ROCKY FLATS SITE REGULATORY CONTACT RECORD 2022-01

Purpose: North Walnut Creek Slump (NWCS) Exploratory Test Pits

Contact Record Approval Date: October 5, 2022

Figure 1. NWCS Exploratory Test Pits Overview

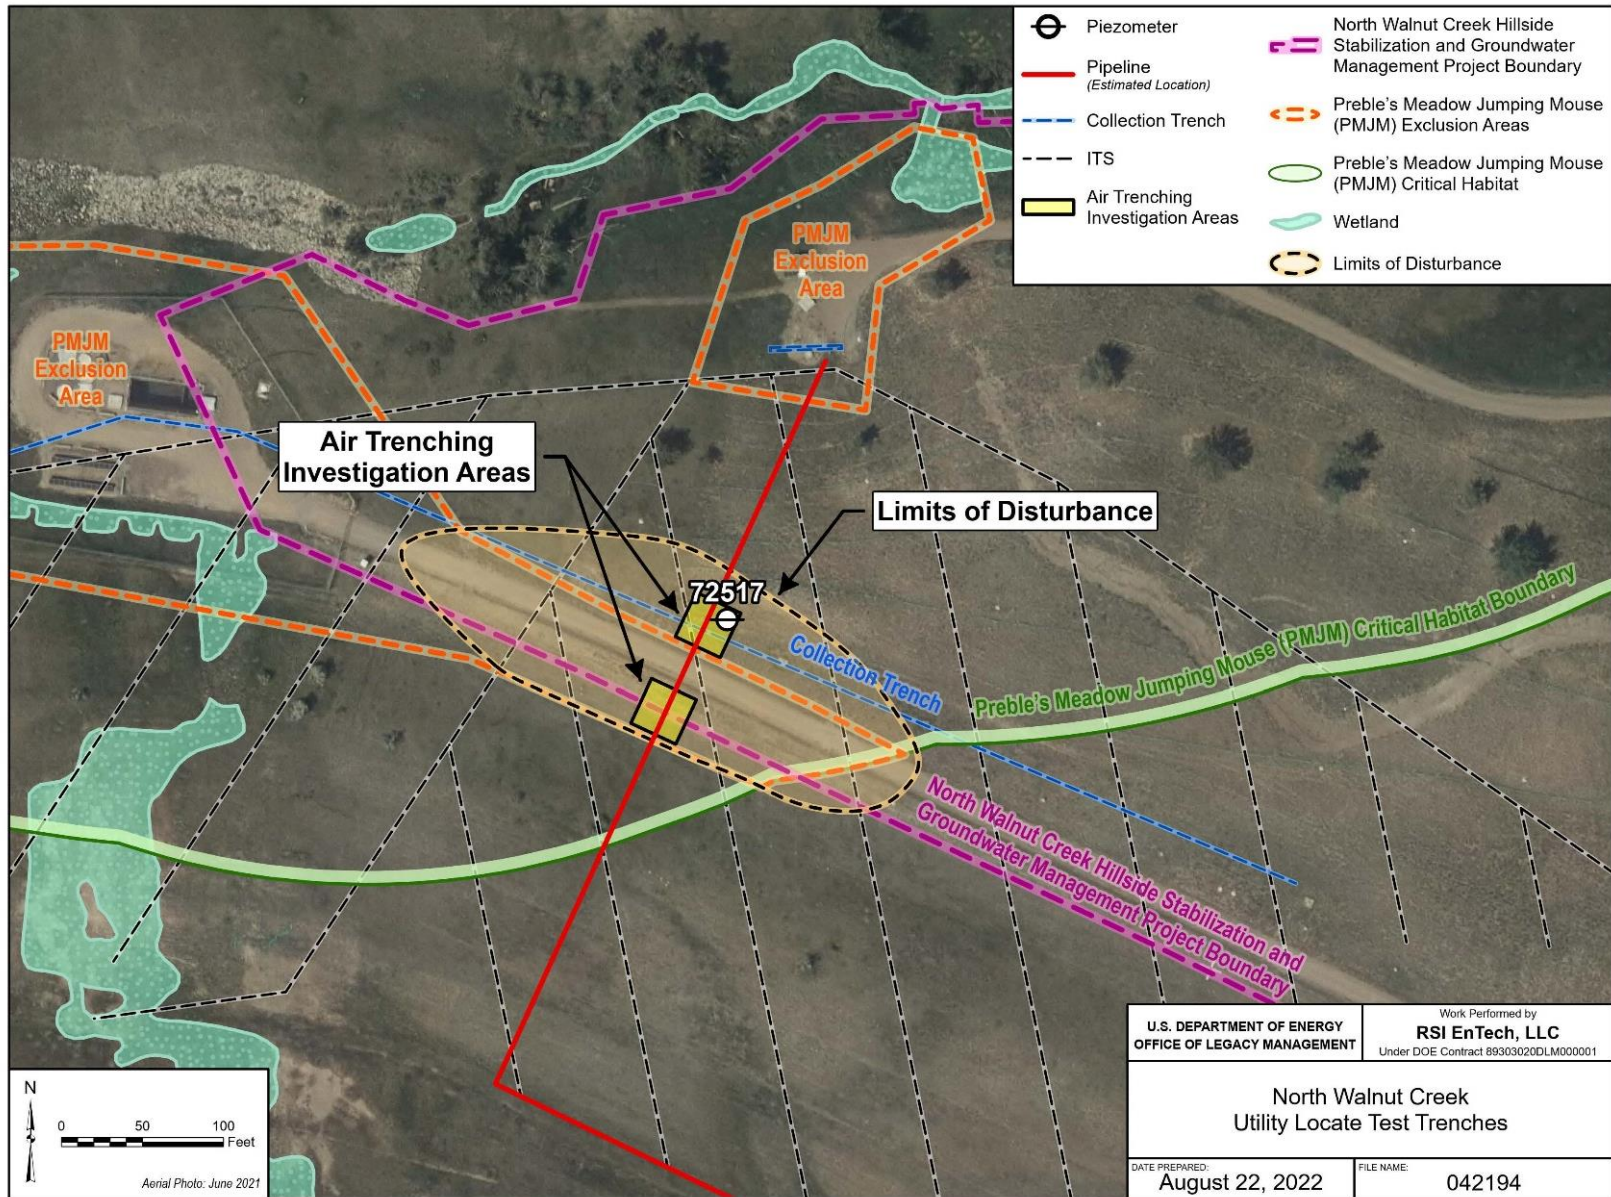
If needed, excavated soil from this activity will be staged nearby within the “limits of disturbance” (Figure 1). Once the identification and confirmation objectives are completed, the excavated soil will be returned to the test pits and compacted to reestablish previous grade. Any temporary soil stockpile will be managed in accordance with all applicable or relevant and appropriate requirements listed in Table 21 of the 2006 *Corrective Action Decision/Record of Decision* and will be consistent with the then in-effect approved *Erosion Control Plan for Rocky Flats Property Central Operable Unit* (currently, DOE-LM/1497-2007).

The exploratory test pits are in Unit 6 of the critical habitat of the Preble's meadow jumping mouse (PMJM) (*Zapus hudsonius preblei*). Activities in PMJM habitat were consulted on in the Rocky Flats Programmatic Biological Assessment, the associated Programmatic Biological Opinion, and subsequent consultation documents. The exploratory test pits are located within the PMJM exclusion area for the SPPTS and/or within the NWCHSGM Project boundary (Figure 1).

CDPHE, after consultation with EPA, has approved the activities described in this contact record (CR). Based on the information provided, CDPHE determined that the proposed activities will not result in an unacceptable release or exposure to residual subsurface contamination and will not damage any component of the remedy. CDPHE has also determined that the proposed activities meet the rationale and objectives of IC 2.
